FINAL DRAINAGE REPORT

FALCON RANCHETTES FILING NO. 2
MERIDIAN STORAGE
El Paso County, Colorado

Add PCD File No.
VR239

DATE:
April 24th, 2023

Project: Meridian Storage
 Inlet ID: DP4

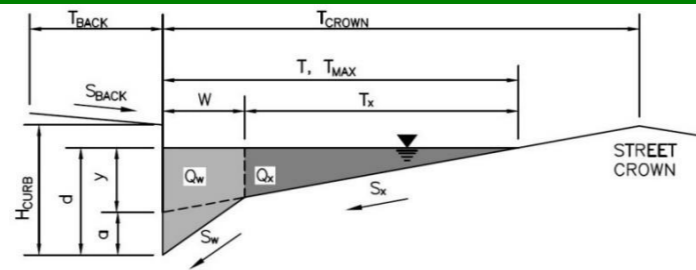
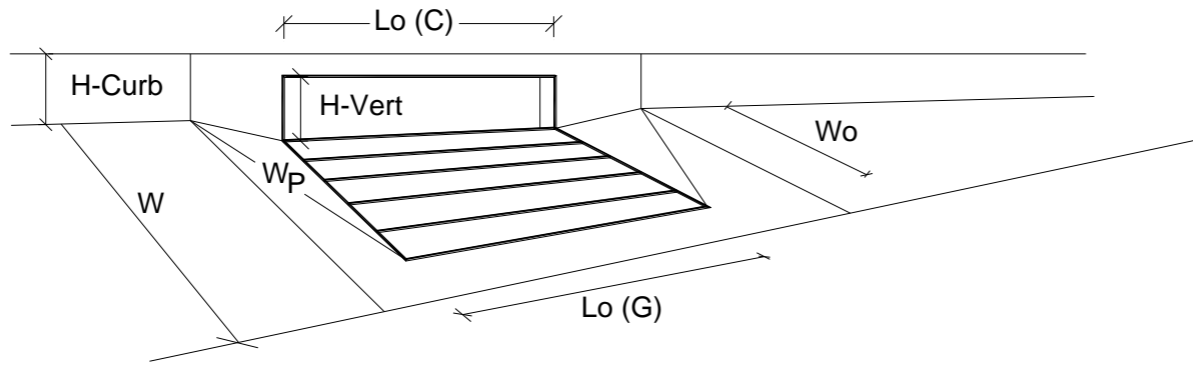
The narrative indicates that Basin B-3 flow is conveyed to this inlet. The flow at basin B-3 is 4.7cfs/8.1cfs (5yr/100yr). Please revise accordingly as it does not appear that the entire flow is being accounted for in this design.
